**ORDINANCE NO. 2239**

**AN ORDINANCE AMENDING THE HERMISTON TRANSPORTATION SYSTEM PLAN THROUGH THE ADOPTION OF THE 2016 AMENDMENT TO THE SOUTH HIGHWAY 395 CORRIDOR REFINEMENT PLAN.**

**TSP Project Recommendations  
Hermiston TSP Update - Ranch & Home**

Re: City of Hermiston Transportation System Plan Update – Ranch and Home Development

**FIGURE 2  
AMENDED CONFIGURATION**

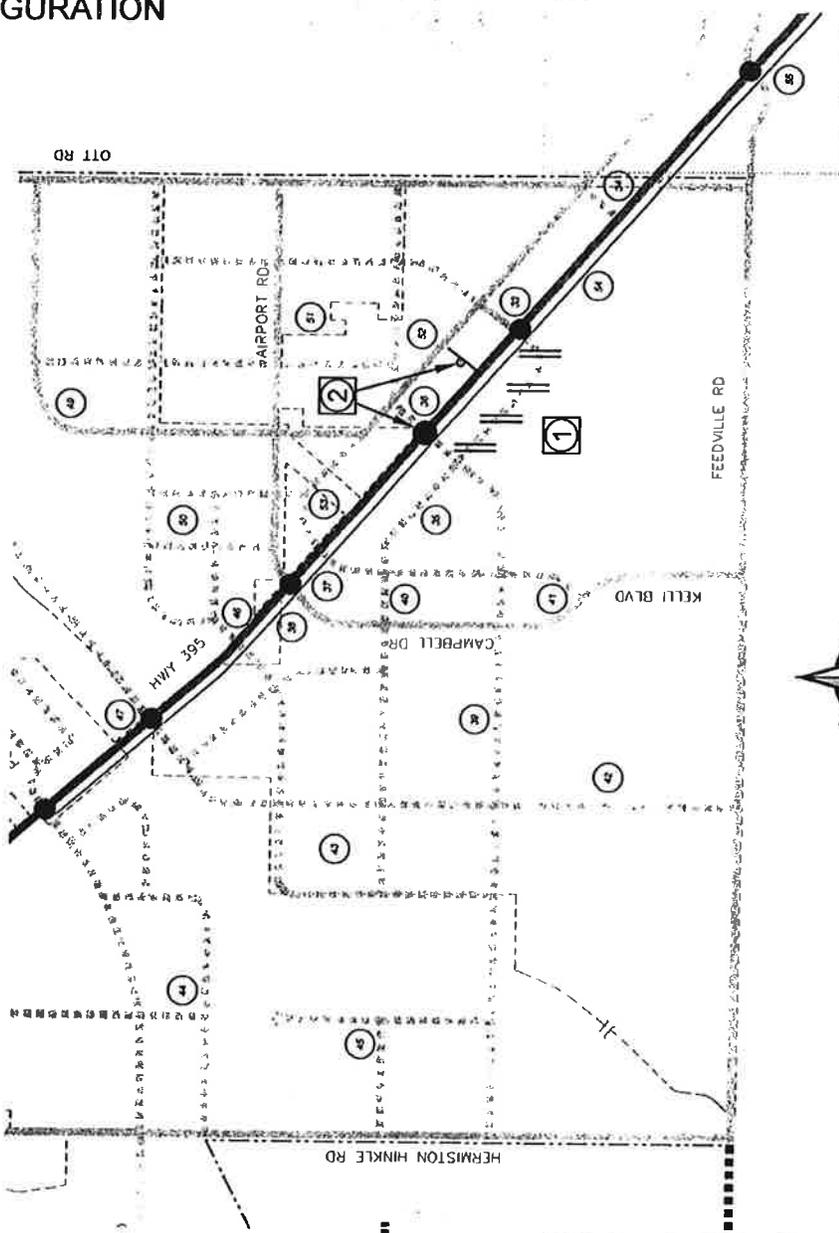
**① REVISE PROJECT TO SHORTEN 35.**

**② REVISE PROJECT 36 TO INCLUDE FULL ACCESS SIGNAL WITH "PREPARE TO STOP WHEN FLASHING" SIGN.**

FIGURE 2

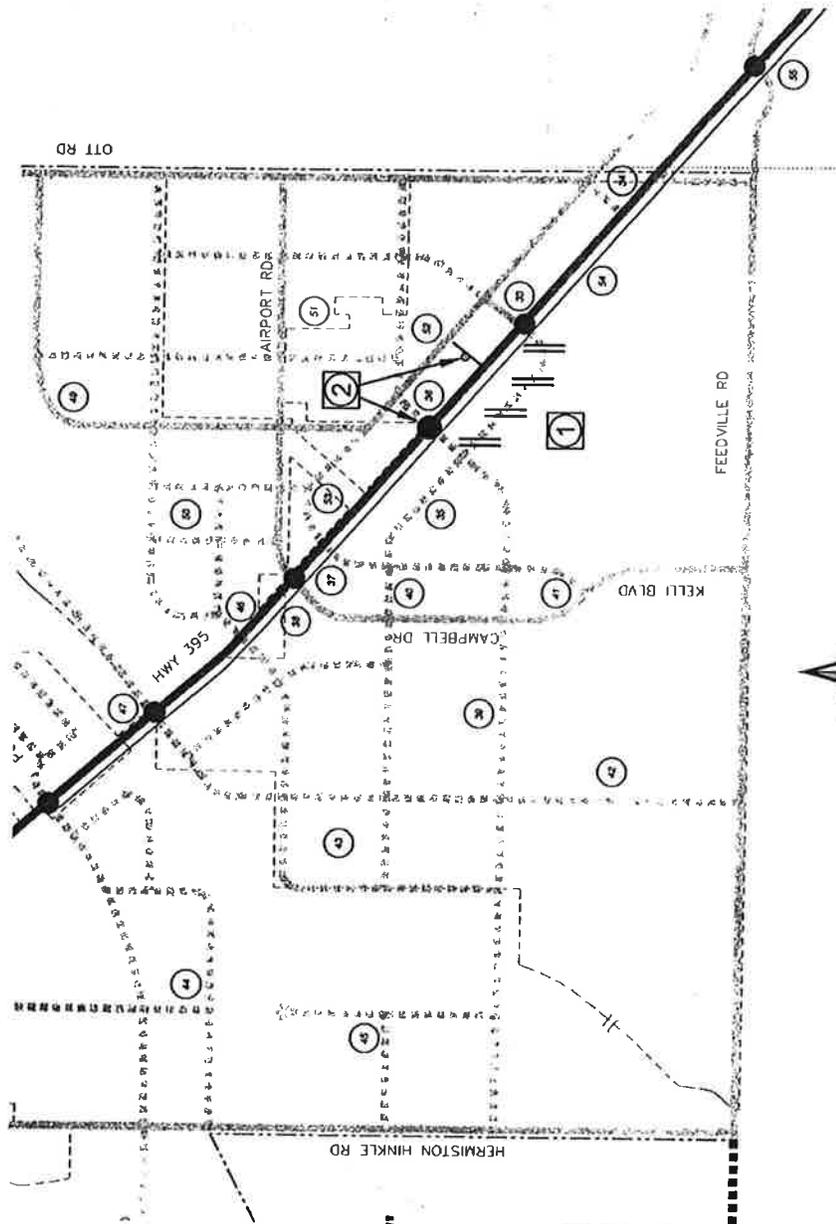
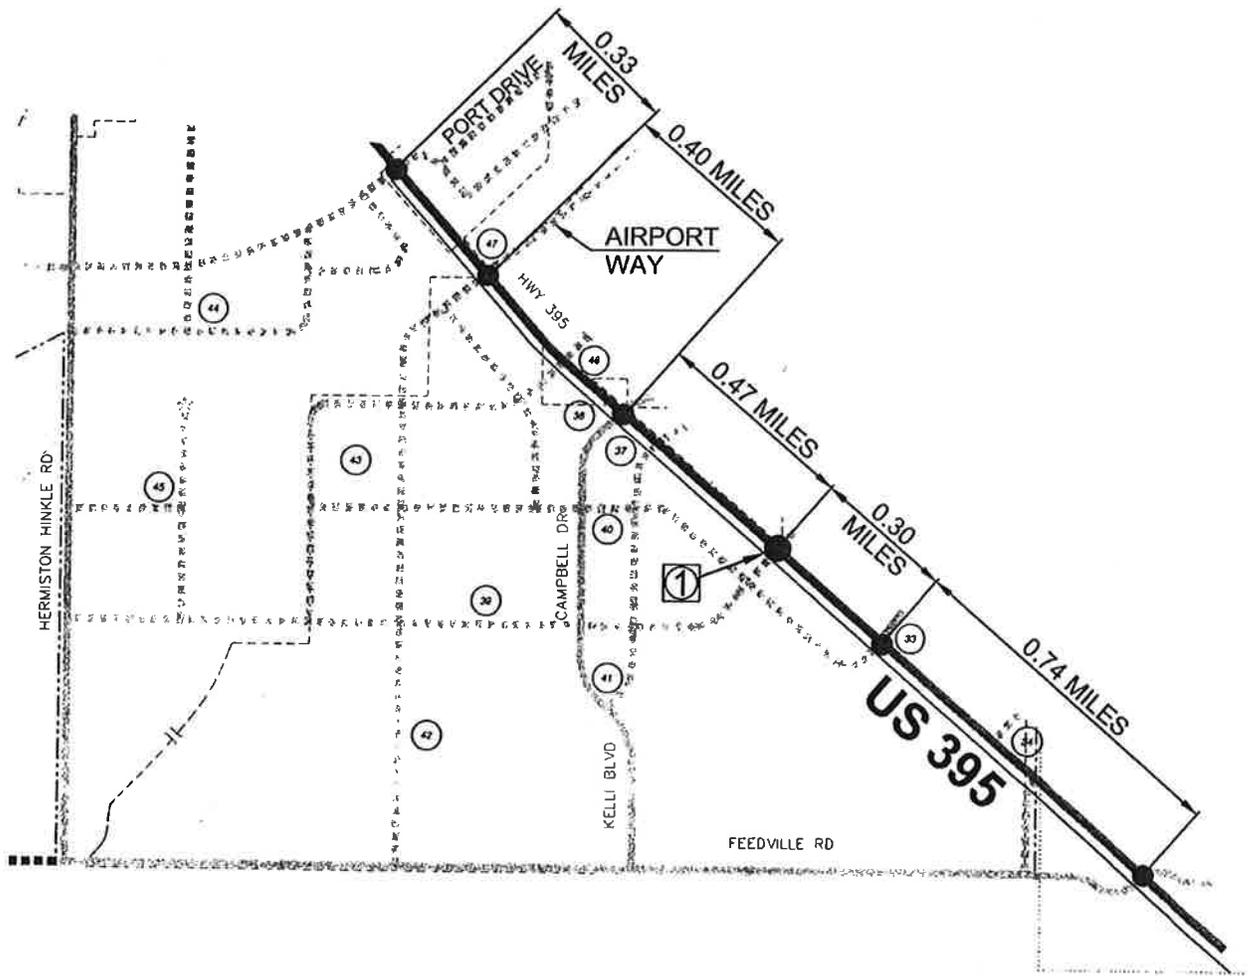
1. Modify Project 35 to shorten proposed minor collector backage road, parallel to US 395, between Kelli Boulevard to the proposed minor arterial listed as Project 39 (Hermiston Foods driveway).
2. Modify project 36 to include a full access traffic signal at the proposed minor arterial intersection with US 395, near the Hermiston Foods driveway. With the proposed traffic signal for the Ranch and Home Development and the Hermiston Foods driveway, include an advance warning sign assembly “PREPARE TO STOP WHEN FLASHING” and advance vehicle detection system.

- ① REVISE PROJECT TO SHORTEN 35.
- ② REVISE PROJECT 36 TO INCLUDE FULL ACCESS SIGNAL WITH "PREPARE TO STOP WHEN FLASHING" SIGN.
